BULLETIN # 2 1

PROJECT: Harrison Recreation & Community Center – PHASE 2
Harrison, NY

RE: Gymnasium Courtline Layout Revision & Related Items

1 GYM COURT LINE REVISIONS
 1/16" = 1'-0"

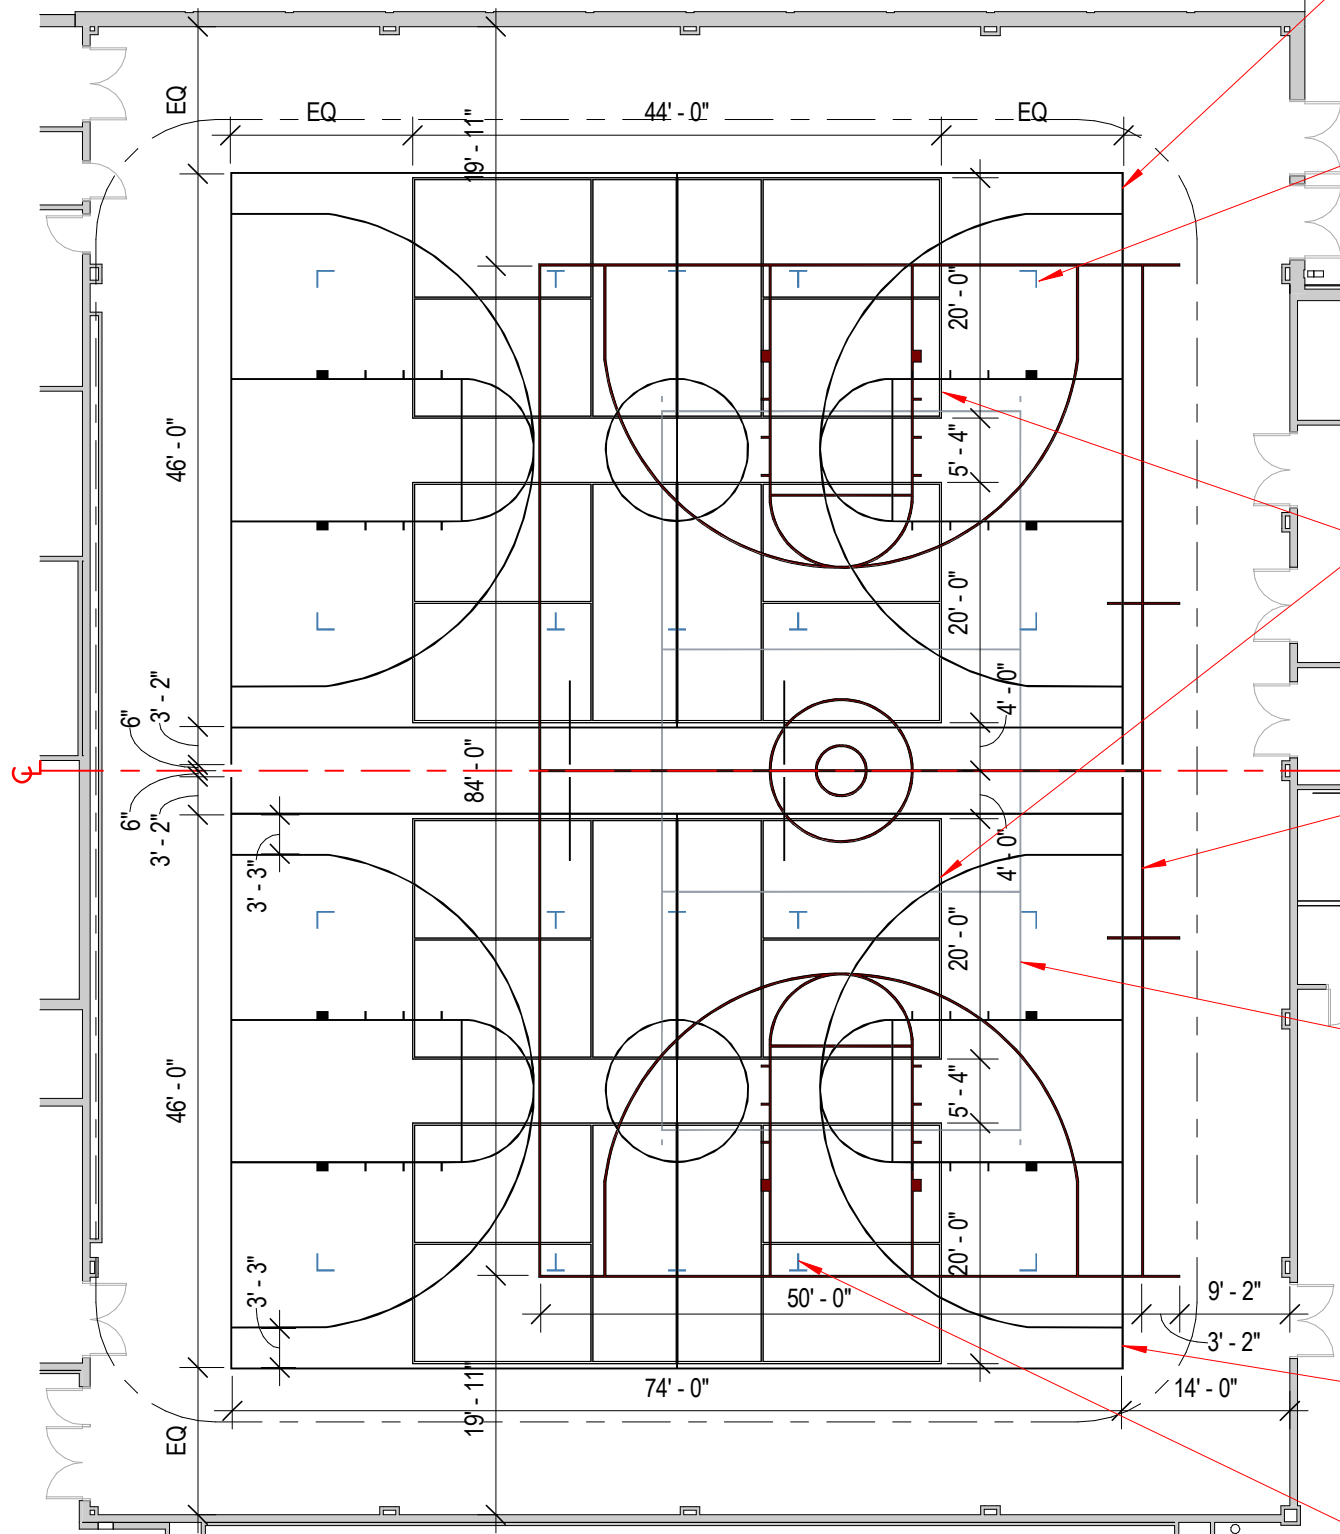
COURT PRIORITY:

- 1. SIDE BASKETBALL (2 COURTS)
- 2. PICKLEBALL (4 COURTS)
- 2. MAIN BASKETBALL (1 COURT)
- 4. MAIN VOLLEYBALL (1 COURT)
- 5. SIDE VOLLEYBALL (2 "TICK" COURTS)

NOTE: AT INTERSECTIONS, THE HIGHER PRIORITY SPORT COURT COLOR WILL BE ON TOP AND THE LOWER PRIORITY WILL HAVE A BREAK IN THE LINE

SIDE BASKETBALL COURT: 46FT x 74FT
 (NOT REGULATION SIZE)
 - BLACK COURT LINES
 (GEN-U-LINE 4000 COURT STANDARD PAINT)

SIDE VOLLEYBALL COURT: 30FT x 60FT
 (REGULATION SIZE)
 - BLUE "TICK" INTERSECTION LINES (Ls & Ts),
 SIZE 18IN LONG
 (GEN-U-LINE 4000 COURT PAINT, CUSTOM
 COLOR TO MATCH TARKETT BLUE FROM
 POLY TURF PAD&POUR COLOR OPTIONS)
 - CENTER COURT WITHIN THE SIDE
 BASKETBALL COURT

PICKLEBALL COURTS (QTY 4): 44FT x 20FT
 (REGULATION SIZE)
 - WHITE COURT LINES
 (GEN-U-LINE 4000 COURT PAINT)
 - 2 COURTS CENTERED WITHIN THE LENGTH
 OF (1) SIDE BASKETBALL COURT

MAIN BASKETBALL COURT: 50FT x 84FT
 (HIGH SCHOOL REGULATION SIZE)
 - MAROON COURT LINES
 (GEN-U-LINE 4000 COURT SUGGESTED
 CUSTOM PAINT)

MAIN VOLLEYBALL COURT: 30FT x 60FT
 (REGULATION SIZE)
 - GRAY COURT LINES
 (GEN-U-LINE 4000 COURT PAINT, CUSTOM
 COLOR TO MATCH SHERWIN WILLIAMS
 DUSTBLU SW9161)
 - CENTER COURT WITHIN THE MAIN
 BASKETBALL COURT

SIDE BASKETBALL COURT: 46FT x 74FT
 (NOT REGULATION SIZE) BLACK COURT LINES

SIDE VOLLEYBALL COURT: 30FT x 60FT
 (REGULATION SIZE)
 - BLUE "TICK" INTERSECTION LINES (Ls & Ts),
 SIZE EACH BRANCH 18IN LONG
 (GEN-U-LINE 4000 COURT PAINT, CUSTOM
 COLOR TO MATCH TARKETT BLUE FROM
 POLY TURF PAD&POUR COLOR OPTIONS)
 - CENTER COURT WITHIN THE SIDE
 BASKETBALL COURT

1 GYM VOLLEYBALL SLEEVES (COURT LINE UPDATE)
1/16" = 1'-0"

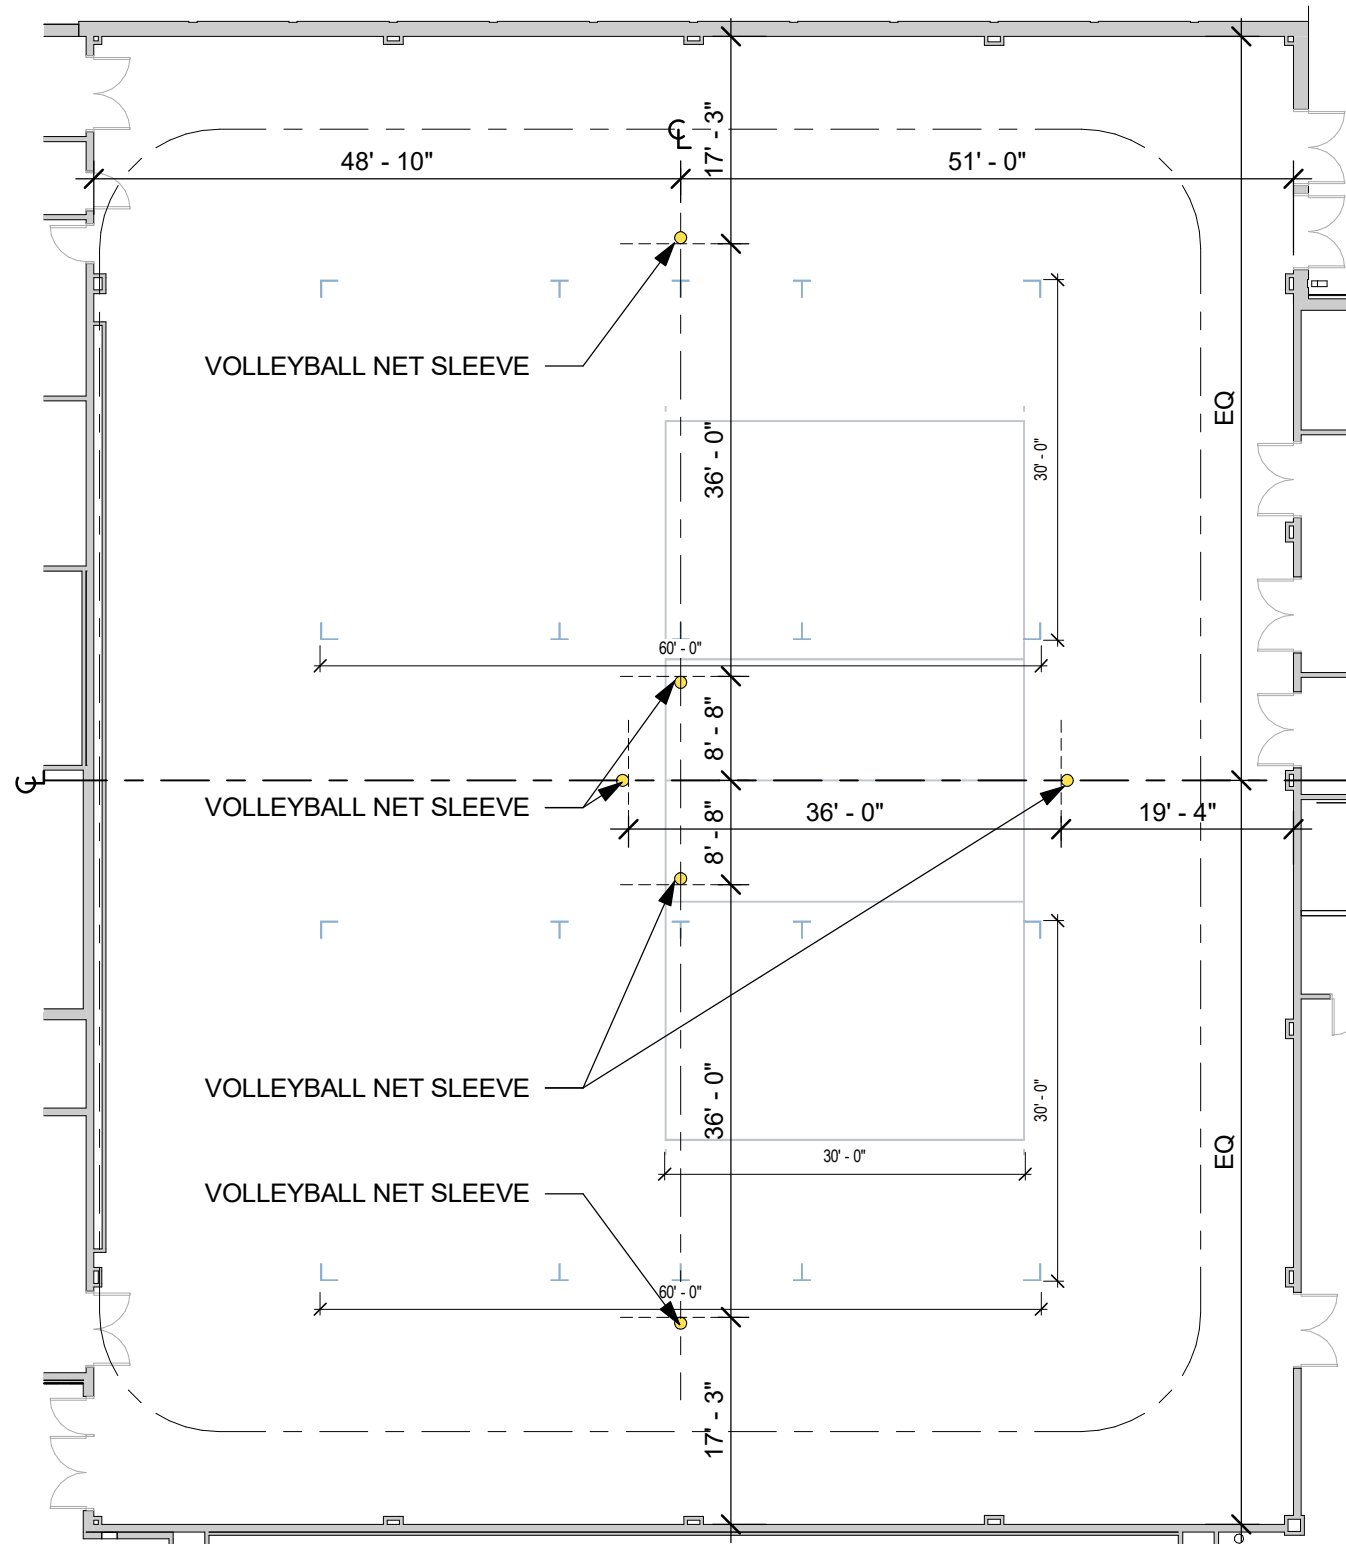
SIZE OF SLEEVE NOT TO SCALE. SEE MANUFACTURERS INFORMATION FOR THE CORRECT RADIUS/DIAMETER. THIS DRAWING IS FOR LOCATING PURPOSES ONLY. ALL DIMENSIONS TO SLEEVES ARE FROM THE COLUMN LINE TO THE CENTERLINE.

1 GYM RCP REVISION (COURT LINE UPDATE)
1/16" = 1'-0"

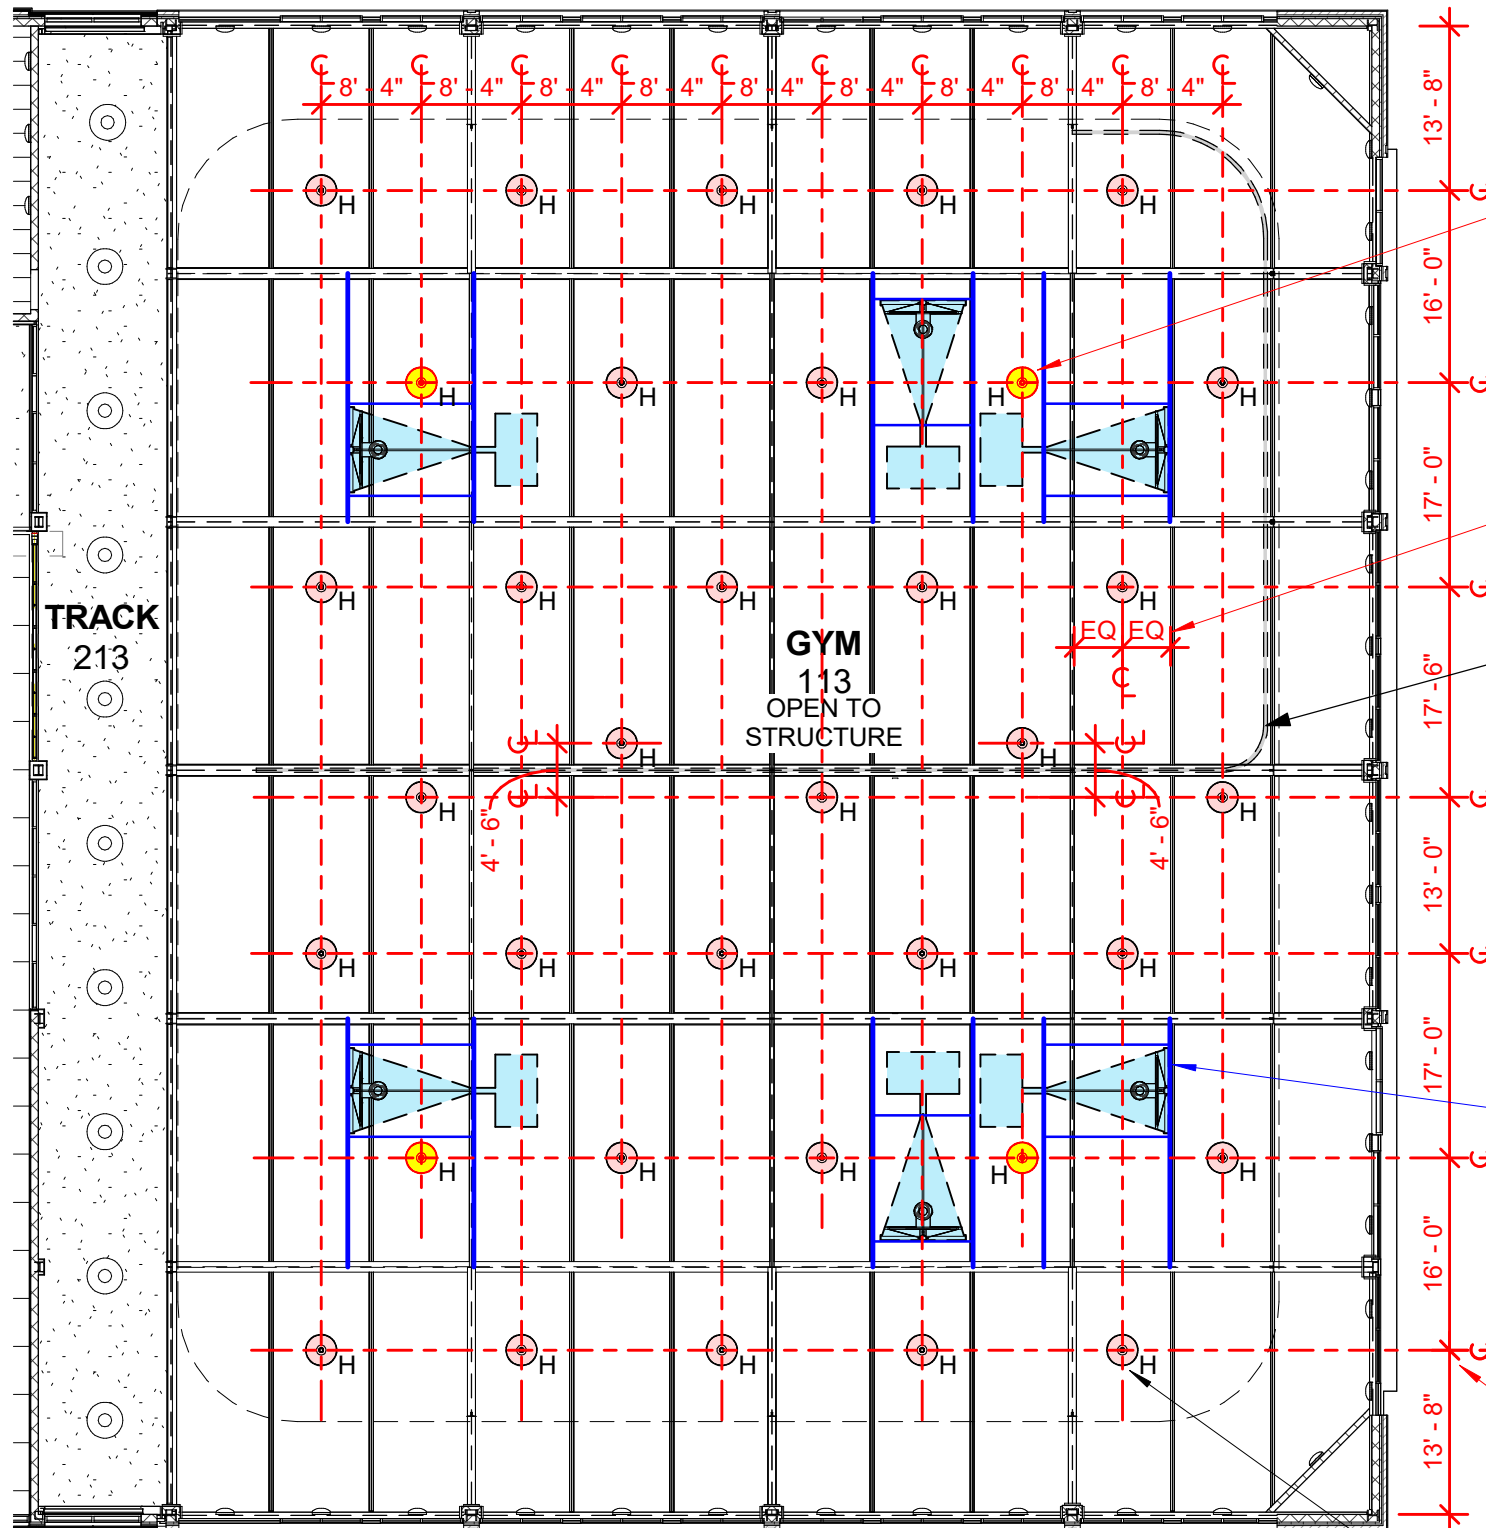
AT THE INDICATED LOCATIONS.
COORDINATE LIGHTING WITH
BASKETBALL HOOPS AND THEIR
SUPPORT STRUCTURE.
(IF ADJUSTMENTS TO LIGHTING ARE
REQUIRED, NOTIFY THE ARCHITECT)

CENTER EACH LIGHT FIXTURE BETWEEN
STRUCTURAL SUPPORTS

GENERAL NOTE:
RELOCATE SPRINKLER HEADS OR OTHER
RELATED CEILING MOUNTED EQUIPMENT
FOR REVISED LIGHTING LAYOUT.
(NOTIFY THE ARCHITECT IF THERE ARE
ANY SIGNIFICANT CONFLICTS)

REVISED BASKETBALL HOOP LOCATIONS:
HOOP MANUFACTURER TO REVISE
SUPPORT STRUCTURE AS REQUIRED FOR
REVISED LOCATIONS. REMINDER TO
COORDINATE WITH THE COURT LOCATION

NEW LIGHTING SPACING:
COORDINATE SPACING WITH DUCTWORK
(IF ADJUSTMENTS TO LIGHTING ARE
REQUIRED, NOTIFY THE ARCHITECT)

FOR GYM 113:
TYPE H FIXTURES TO BE MOUNTED AT
25'-0" AFF TO BOTTOM OF FIXTURE - TYP
